WILLIAMSON COUNTY, TEXAS

CHANGE ORDER NUMBER: 1

Project: 23IFB6

Roadway: CR 404 at FM 973

SHEET 6 OF 16

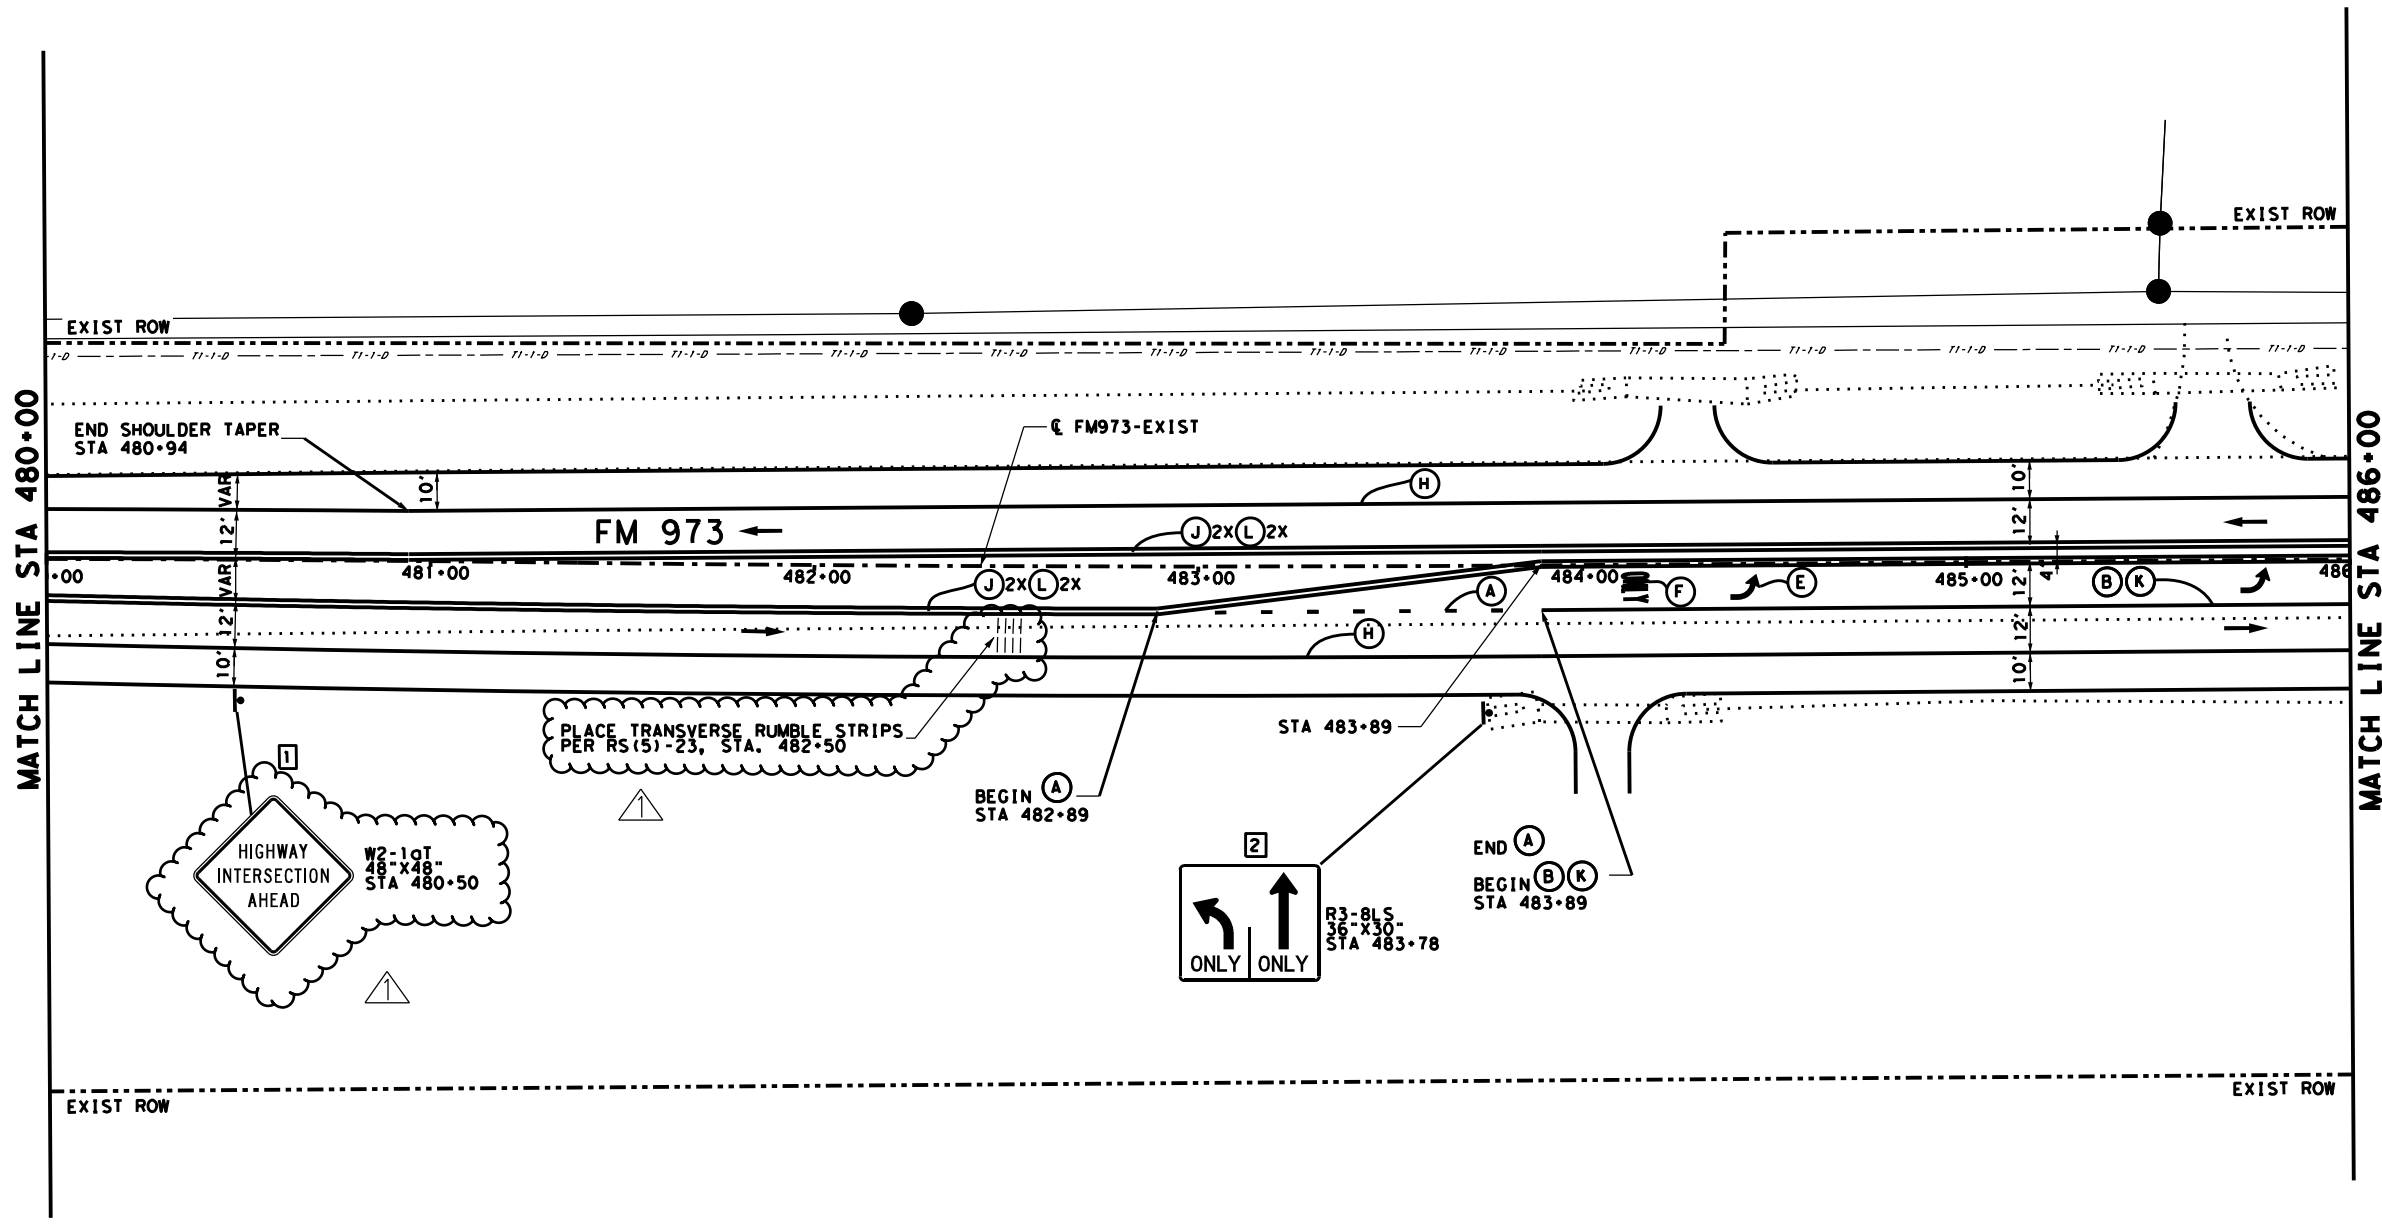
| NO. | REVISIONS | BY | DATE |
|-----|-------------------|----|---------|
| | ADD RUMBLE STRIPS | RK | 5/12/23 |

SHEET 7 OF 16

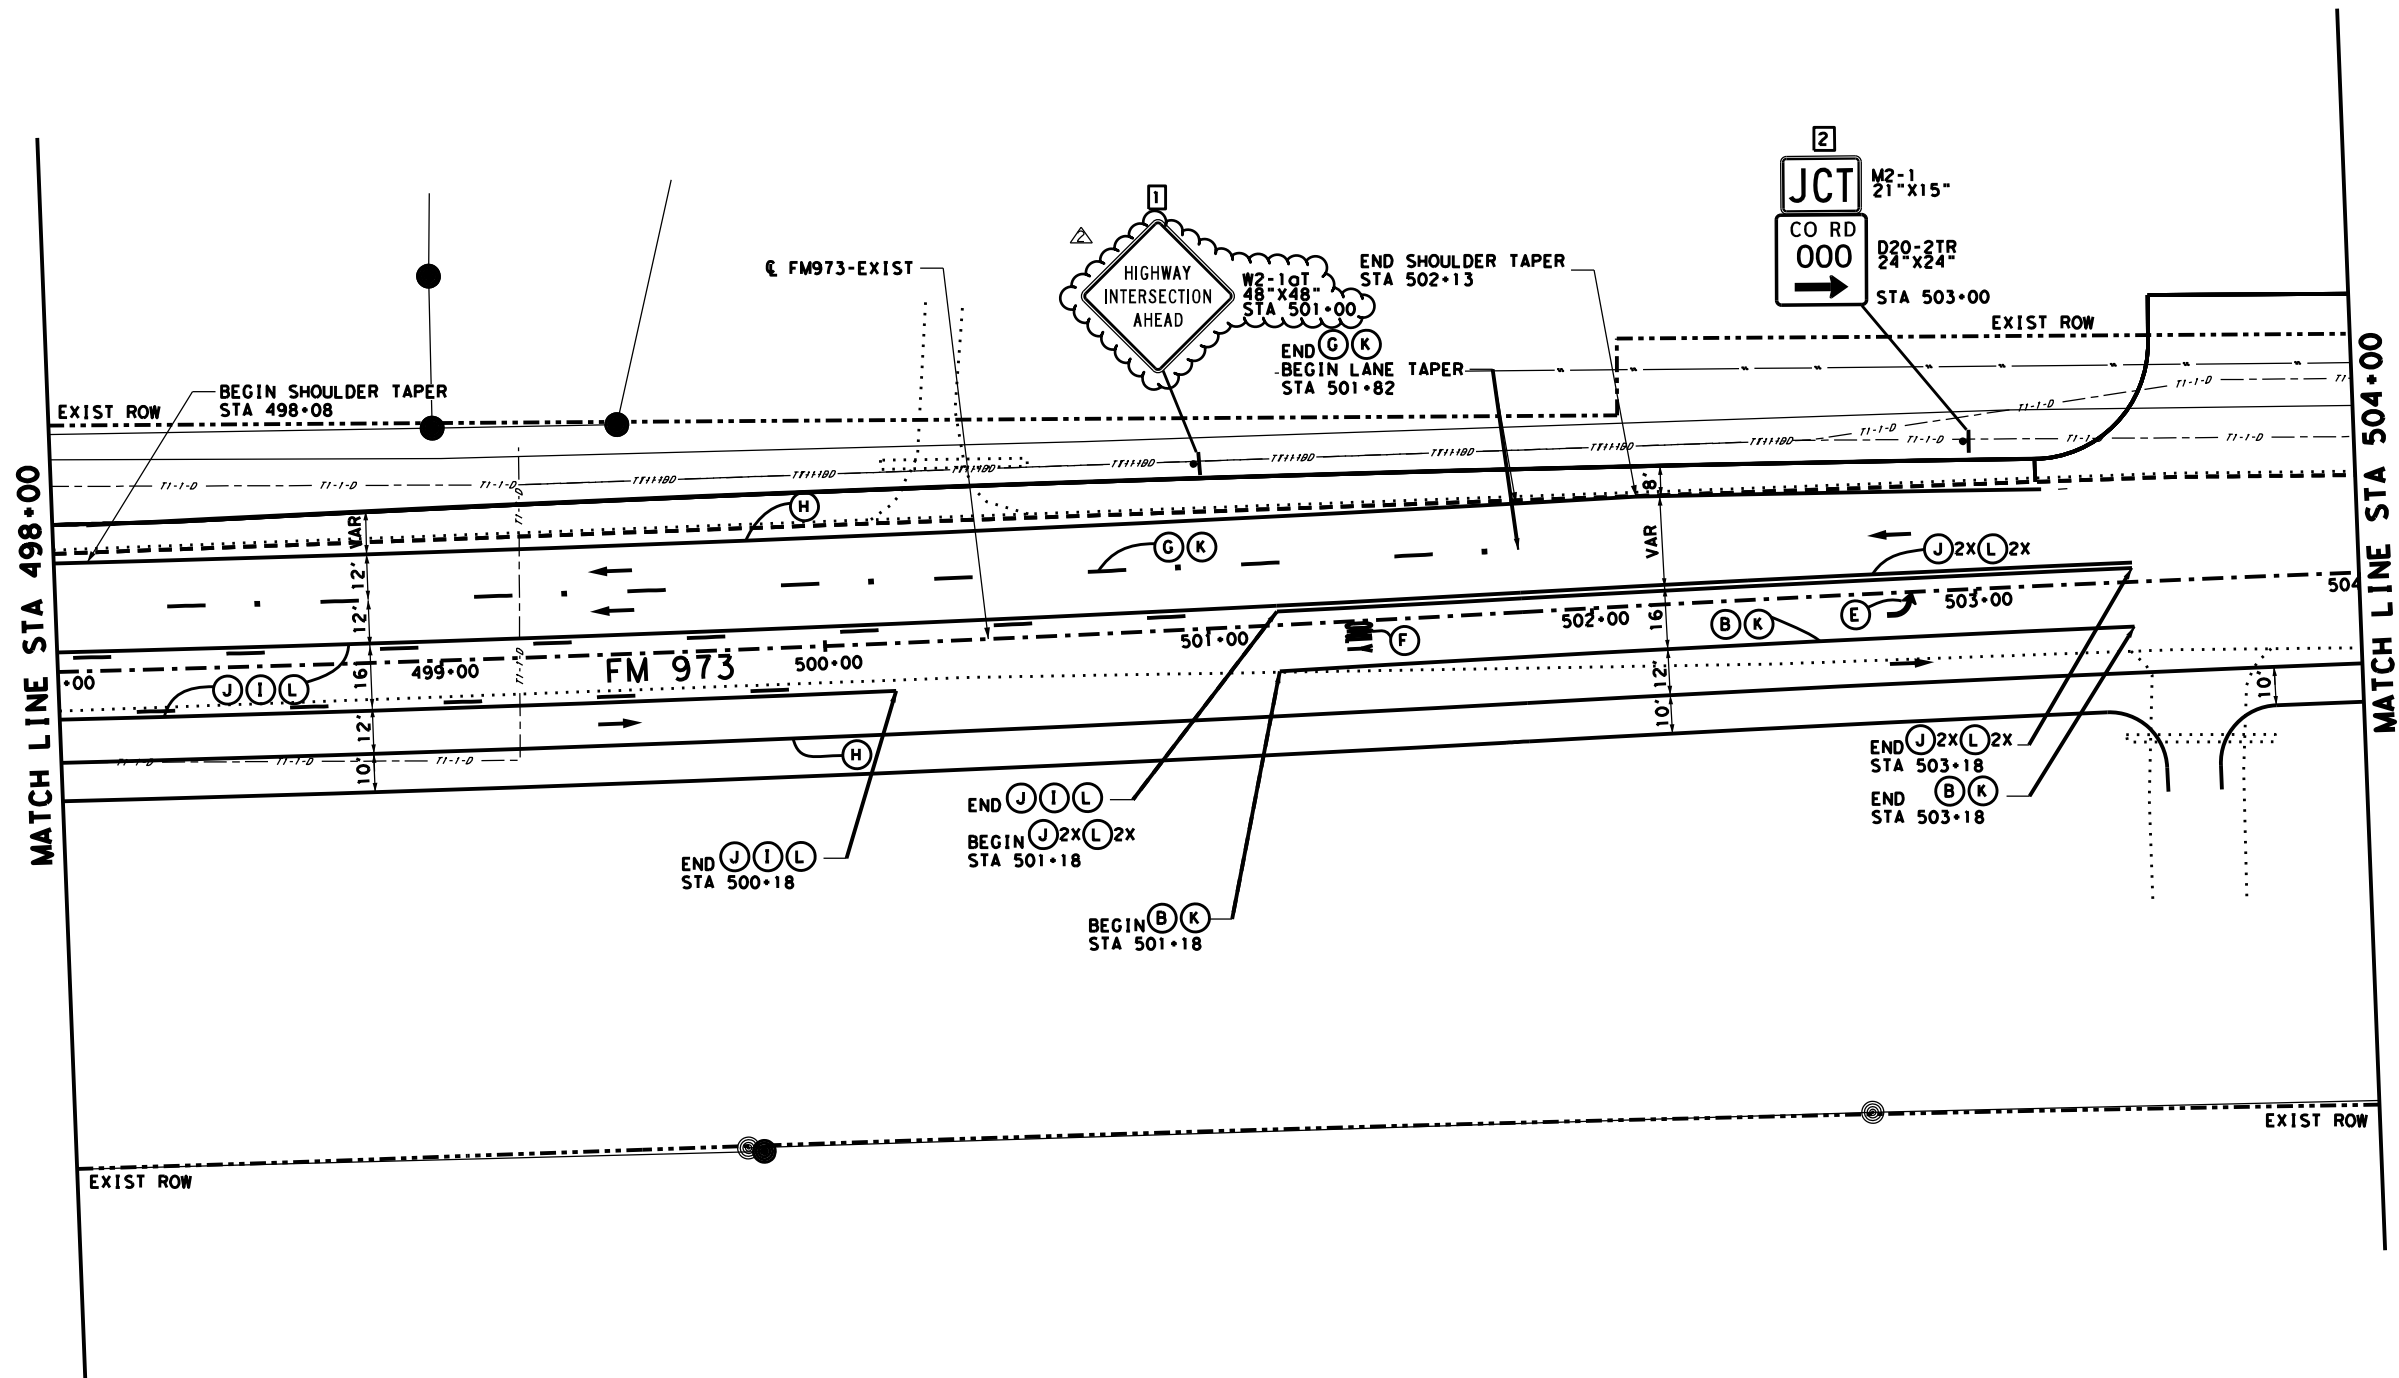
| NO. | REVISIONS | BY | DATE |
|-----|-------------------|----|---------|
| | ADD RUMBLE STRIPS | RK | 5/12/23 |

SHEET 12 OF 16

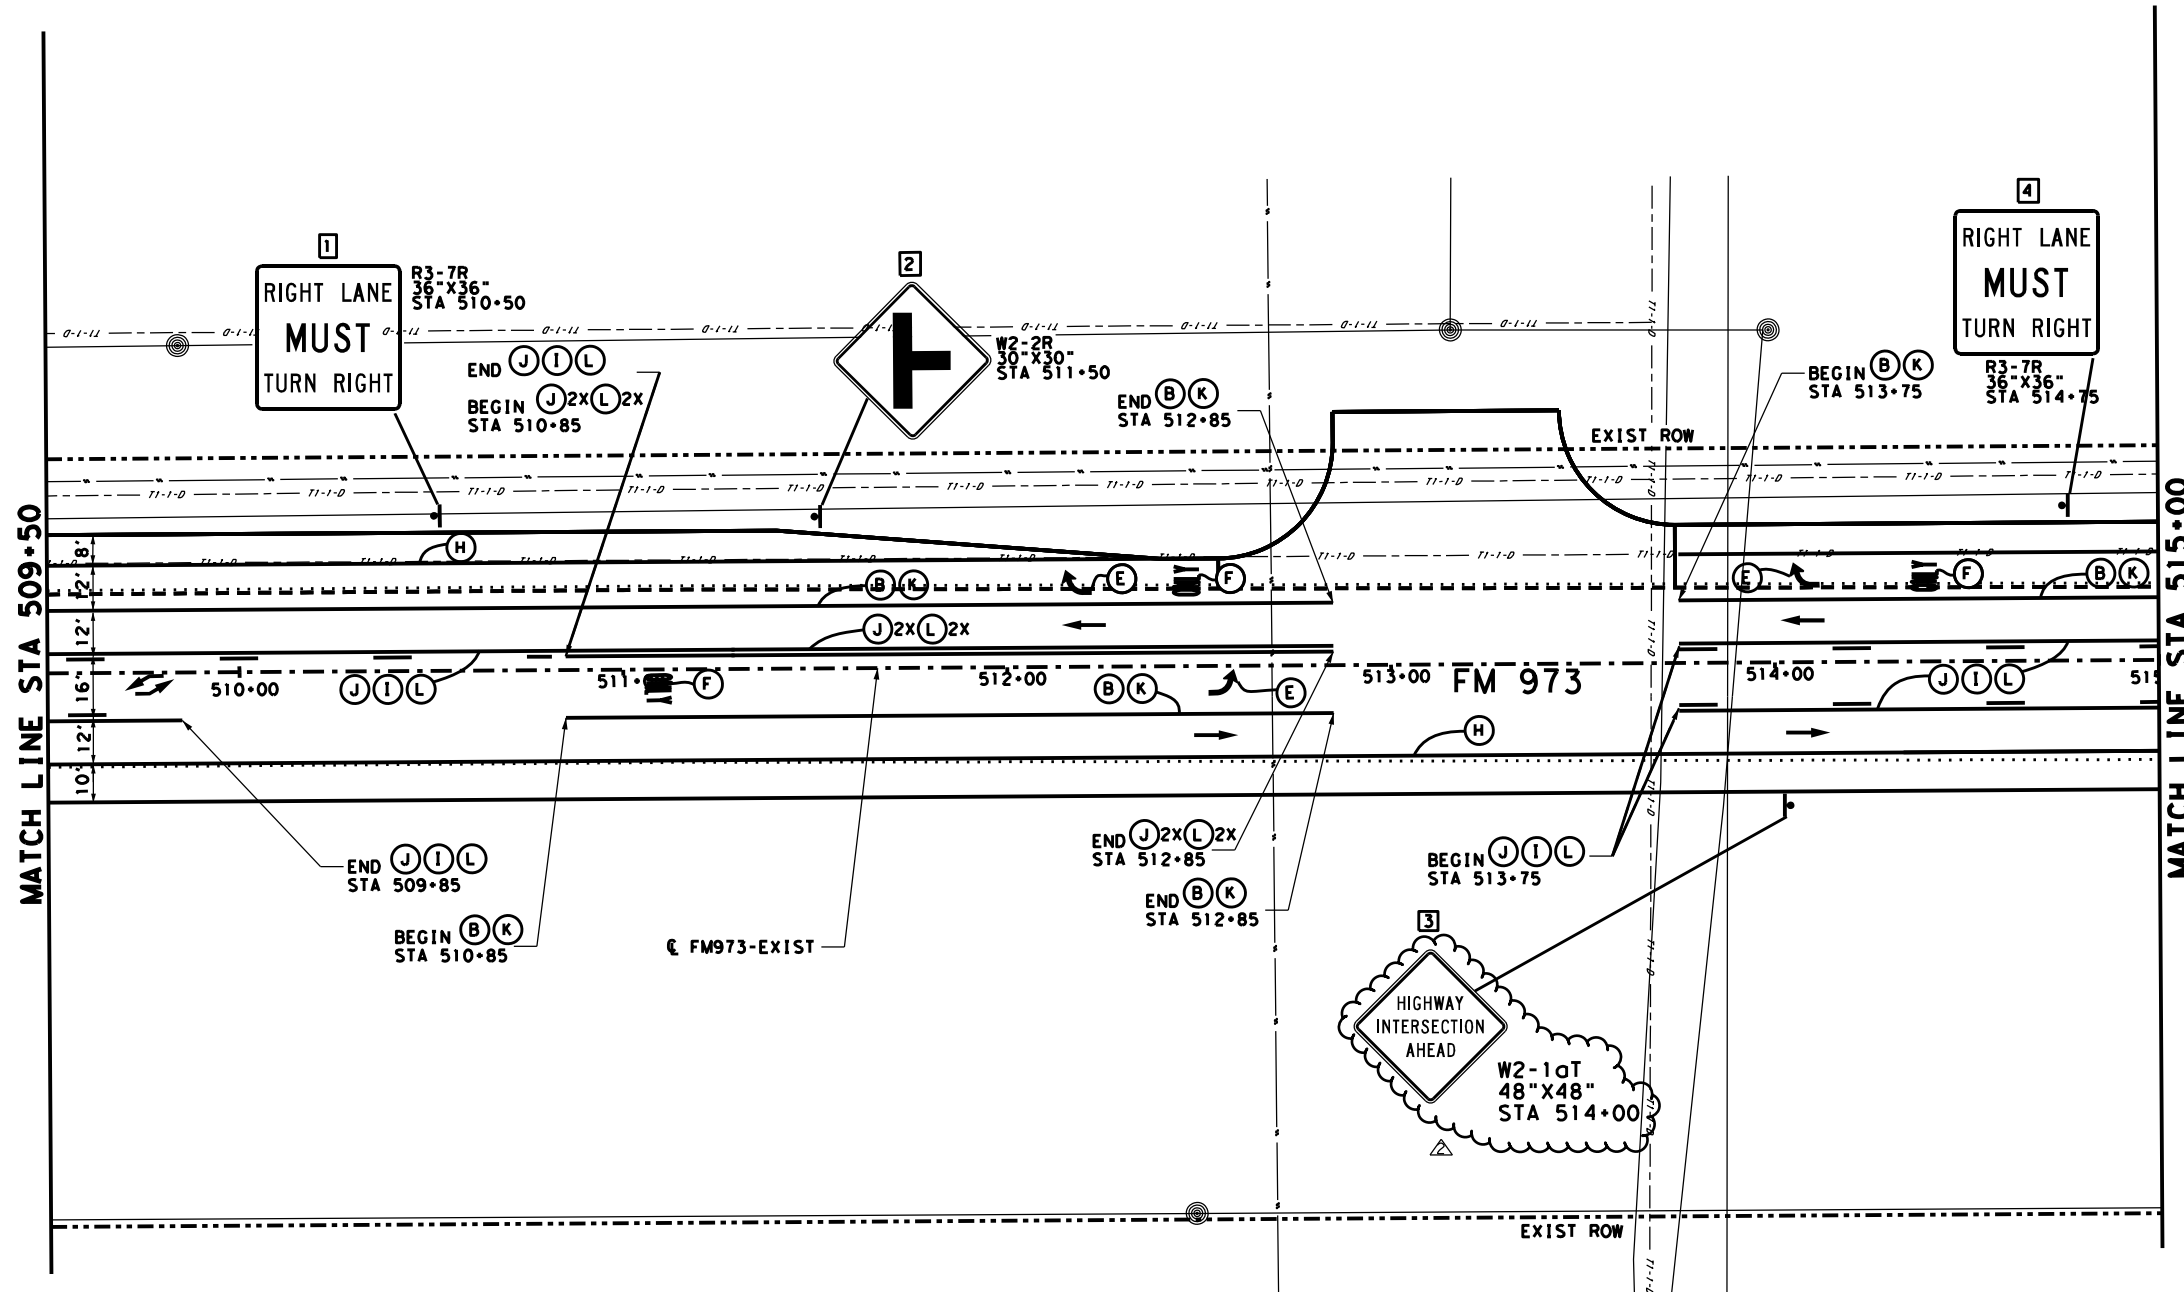
| NO. | REVISIONS | BY | DATE |
|-----|----------------------------|----|---------|
| 1 | SAMSUNG DRIVEWAY REVISIONS | RK | 2/14/23 |
| 2 | ADD RUMBLE STRIPS | RK | 5/12/23 |
